Transportation Safety Equipment Institute

Re: Advance Notice of Proposed Rulemaking; Federal Motor Vehicle

Safety Standards: Test Procedures [Docket No. NHTSA-2020-

0109]; 85 Fed. Reg. 79456 (Dec. 10, 2020)

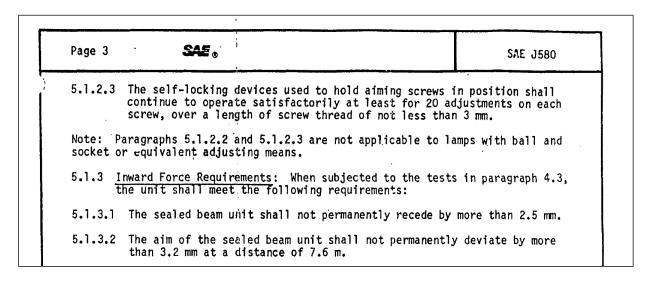
As the Agency evaluates potential changes to FMVSS 108, TSEI urges the Agency to consider adding language to clarify that turn signal lamps and stop lamps designed for use on vehicles 2032 mm or more in overall width, that meet the one lighted section photometric values, may be used on narrower vehicles. We note that SAE J1395 APR85 and SAE J1398 MAY85, from which the relevant provisions within current FMVSS 108 were derived, expressly permit this by stating in their "Scope" section that lamps meeting the requirements for wider vehicles may also be used on narrower vehicles. The Agency arrived at the same conclusion in an August 22, 1990 interpretation letter to Hella. In that letter, the Agency stated:

newly adopted rule permitted use of J1395-compliant turn signal lamps on narrower vehicles. (J1398 contains nearly identical language and, therefore, this interpretation should apply equally to stop lamps.) The industry had relied on this interpretation for many years, but the Agency addressed this issue during its "administrative rewrite" of FMVSS 108 and rejected the argument that FMVSS 108, as it existed prior to the rewrite, permitted use of J1395/J1398-compliant lamps on narrower vehicles. *See* Response to Petitions for Reconsideration, 76 *Fed. Reg.* 48008, 48020 (Aug. 8, 2011). As such, the issue was deemed outside the scope of the rewrite, which was not intended to make substantive changes to the standard. Thus, to the extent it does constitute a substantive change, we urge the Agency to consider adopting this change during any future rulemaking related to FMVSS 108.
